## PERMIT MODIFICATION APPROVAL

Re: Permit Modification Approval for API Number 8510155, Well #: GREENBACK UNIT  
1H

**Move laterals to accomodate 660 ft spacing**

**API# 47-085-10155 PERMIT MODIFICATION**

JOB # 14-065WA  
 DRAWING # GREENBACK1HR2  
 SCALE 1" = 1000'  
 MINIMUM DEGREE OF ACCURACY SUBMETER  
 PROVEN SOURCE OF ELEV. SUBMETER MAPPING GRADE GPS

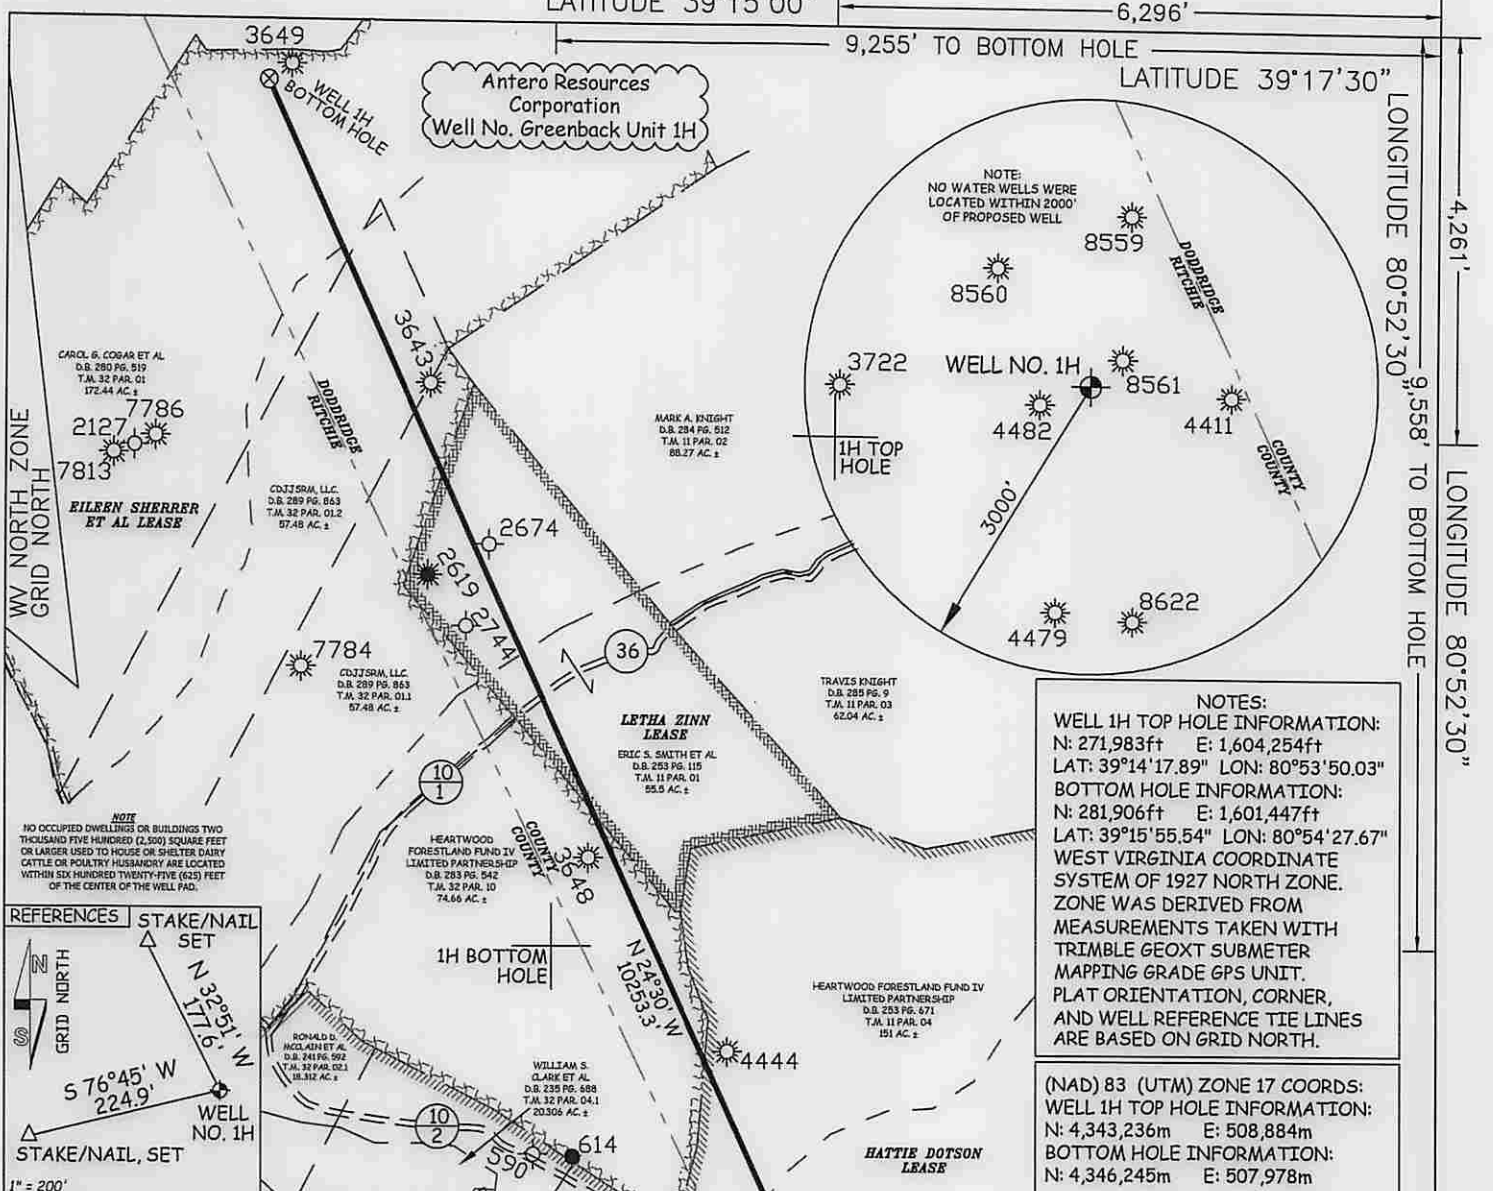
Antero Resources Corporation (Antero) would like to submit the following permit modifications for three approved wells on the Mackay Pad. We are requesting to move the horizontal laterals to accommodate 660 foot spacing between wells, which will change the bottom hole locations of the Caldwell Unit 1H (API# 47-085-10154), Greenback Unit 1H (API# 47-085-10155) and Greenback Unit 2H (API# 47-085-10156). Please note that the revised laterals and bottom hole locations will not be drilling through any new leases; therefore, a revised Form WW-6A1 has not been included.

- REVISED Form WW-6B, which shows the revised lateral lengths, updated measured depths and Production Casing/Cement programs
- REVISED Mylar Plat, which shows the new bottom hole location

**NOTES:**  
 WELL 1H TOP HOLE INFORMATION:  
 N: 271,983ft E: 1,604,254ft  
 LAT: 39°14'17.89" LON: 80°53'50.03"  
 BOTTOM HOLE INFORMATION:  
 N: 281,906ft E: 1,601,447ft  
 LAT: 39°15'55.54" LON: 80°54'27.67"  
 WEST VIRGINIA COORDINATE SYSTEM OF 1927 NORTH ZONE. ZONE WAS DERIVED FROM MEASUREMENTS TAKEN WITH TRIMBLE GEOXT SUBMETER MAPPING GRADE GPS UNIT. PLAT ORIENTATION, CORNER, AND WELL REFERENCE TIE LINES ARE BASED ON GRID NORTH.

PROPOSED WORK: DRILL  CONVERT  DRILL DEEPER  REDRILL  FRACTURE OR STIMULATE   
 PLUG OFF OLD FORMATION  PERFORATE NEW FORMATION  OTHER PHYSICAL CHANGE IN WELL  
 (SPECIFY) Permit MOD-BHL 1600' Spacing PLUG & ABANDON CLEAN OUT & REPLUG  
 TARGET FORMATION MARCELLUS ESTIMATED DEPTH 6,700' TVD 17,600' MD
